AMENDED PLAN No 2011/1168

EXISTING SIDE
WEST

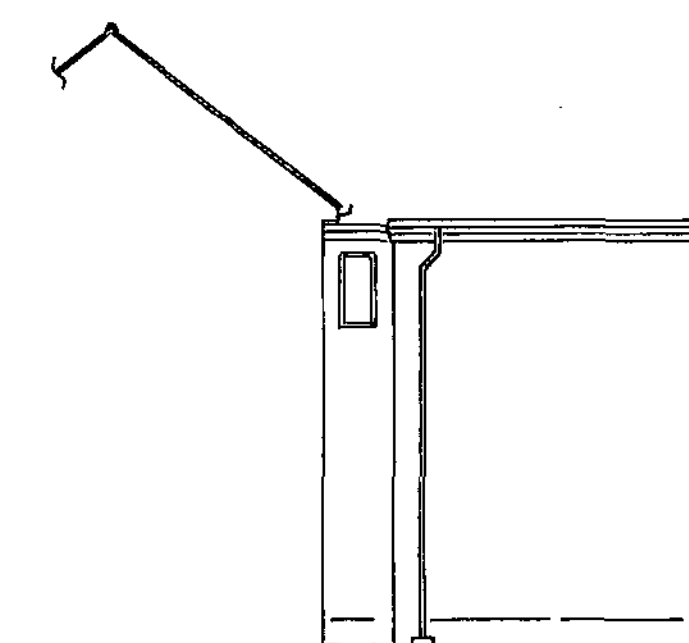
IF THE HEIGHT OF THIS ROOF IS REDUCED THEN THE SHALLOWER PITCHED SLOPE OF 31° (ADJACENT TO No 9 LEVILLE HOUSE) WOULD BE REDUCED FURTHER IN PITCH TO AROUND 27° - AS SLATES ARE NOT VERY EFFICIENT AT PITCHES LESS THAN 30° IT WOULD BE NECESSARY TO USE CONCRETE TILES ON THIS SLOPE AND THEN FOR THE REST OF THE ROOF IN ORDER TO PROVIDE A COMMON ROOFING MATERIAL.
